Access Compliance Report

Public Rights-of-Way

Intersection ID: 14901	Main Street: BALTIMORE_AV	Cross Street: FAIRWOOD_AV	Location:	N
ADA ID: 5011F72844DC	Ramp Type: PerpDiag	Initial Pass/Fail: Fail	Overall Compliance: No	Severity Score: 13.75
Codes/Mitigation Info/Possible Solution		Field Measurements/Component Compliance

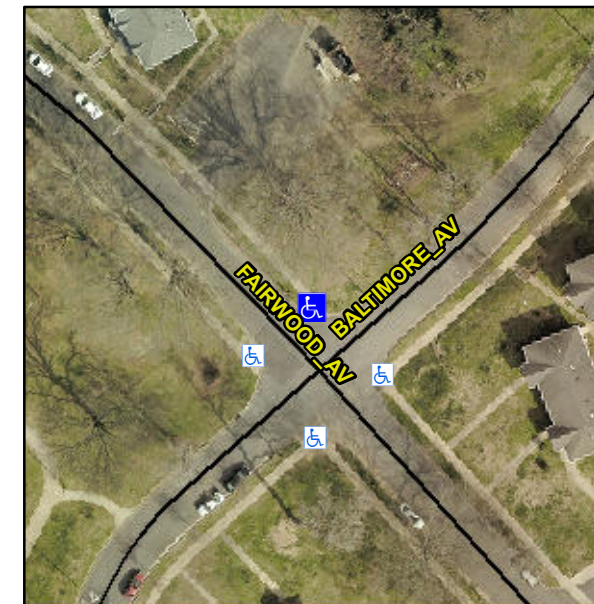
R304.2.2, R304.5.3

Compliance	Description	Data	Compliance	Description	Data
N/A	Ramp Length (in)	53.0	No	Ramp Slope (%)	9.5
Yes	Ramp Width (in)	48.0	No	Ramp XSlope (%)	4.5
N/A	Flare Type LT	N/A	N/A	Flare Type RT	N/A
N/A	Flare Slope LT (%)	N/A	N/A	Flare Slope RT (%)	N/A
N/A	Flare Traversable LT?	N/A	N/A	Flare Traversable RT?	N/A
N/A	Landing Length (in)	N/A	N/A	DWS Provided?	N/A
N/A	Landing Width (in)	N/A	N/A	DWS Contrast?	N/A
N/A	Landing Slope (%)	N/A	N/A	DWS Length (in)	N/A
N/A	Landing X Slope (%)	N/A	N/A	DWS Full Width?	N/A
N/A	Landing Curb? (Y/N)	N/A	N/A	DWS Offset (in)	N/A
N/A	Shared Landing?	N/A			
N/A	Gutter Ponding?	N/A	N/A	Gutter Slope (%)	N/A
N/A	Gutter Lip Ht (in)	N/A	N/A	Gutter X Slope (%)	N/A
N/A	Painted X Walk1?	No	N/A	Painted X Walk2?	No
	X Walk 1 Direction	To SW		X Walk 2 Direction	To SE
N/A	X Walk 1 Width (in)	N/A	N/A	X Walk 2 Width (in)	N/A
	X Walk 1 Slope (%)	5.9		X Walk 2 Slope (%)	6.1
	X Walk 1 X Slope (%)	4.7		X Walk 2 X Slope (%)	3.5

Remove & Replace Curb Ramp With Two New Directional Ramps or Equivalent.
